AZ DISPLAYS, INC. Complete LCD Solutions	ENGINEER CHANGE NOTICE	ECN NO.
		2022-0303A
		Issue Date
		03/03/2022

Part number	ACM2004D-FL-YBS-D,AGM1232G-FL-GBH,AGM1232G-FL-GBH-D, ACM0802C-FL-GBS-NC
Reason for change	Backlight module needs to switch to "side lit" LEDs

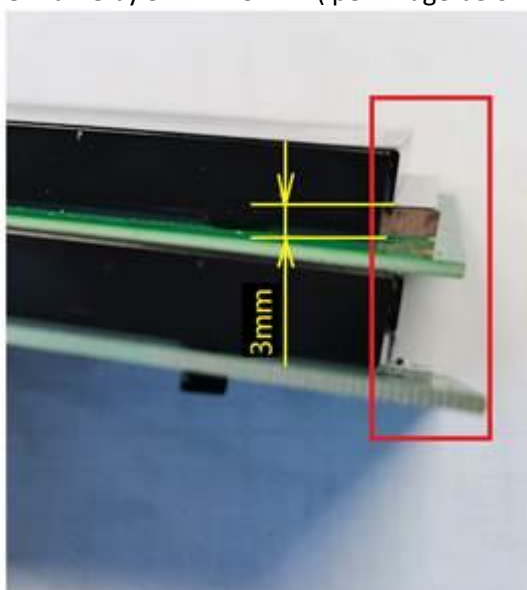
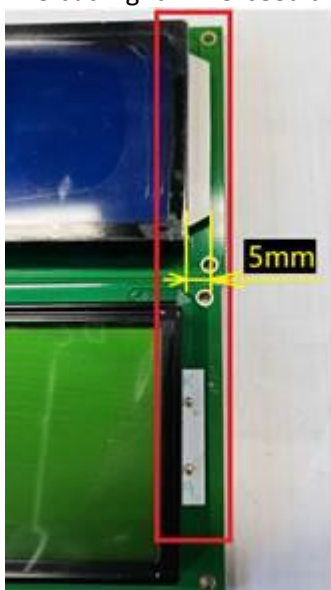
1. The backlight will exceed the bezel frame by 5 mm x 3 mm (per image below).
